Development Application DA2024/0155 at 35 Consul Road, Brookvale – Response to Additional Information Request

We write in response to Council's Request for Information (RFI) dated 24 April 2024. This RFI requests additional information and amendments to address flood risk concerns. In response to the matters raised by Council's Natural Environment Unit, we have provided revised Architectural Plans. The following amended documents accompany the RFI response:

Figure 1: Existing Brick Wall

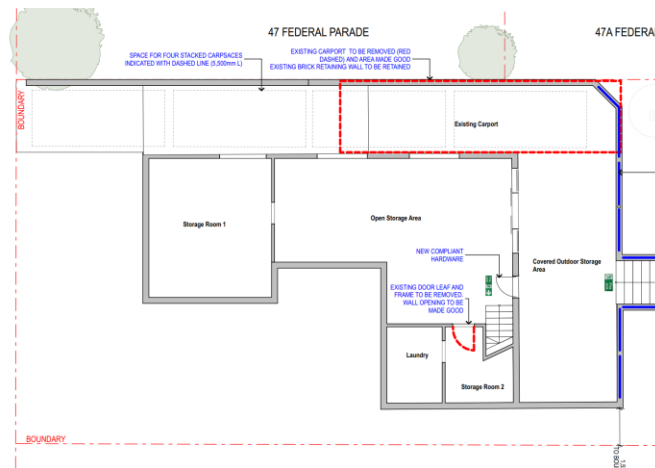
There are inconsistencies between the provided architectural plans and flood management report. The architectural plans indicate that the brick wall along the northern boundary of the property is going to be extended 3m in either direction. During flooding events, including the 1 in 100-year flood event, a floodway flows from the northwest of the property to the south east. This wall extension impacts this flow path.

The flood management report has not addressed this extension or the impacts on the existing flood regime and states there is "no alteration of external components of the site". This contradicts the wall extension in the plans. Further clarification is required.

In response to the matters raised by Council's Natural Environment Unit, the Architectural Plans have been amended to remove the proposed 3m brick wall extension to the east of the northern boundary. By removing the brick wall extension, the floodway that flows from the northwest of the property to the southeast will no longer be impacted.

To note, the previously submitted plans were misleading in that the existing brick wall extends all the way to the driveway entrance, as shown in Figure 1 and the updated Lower Ground Floor Plan in Figure 2 below.
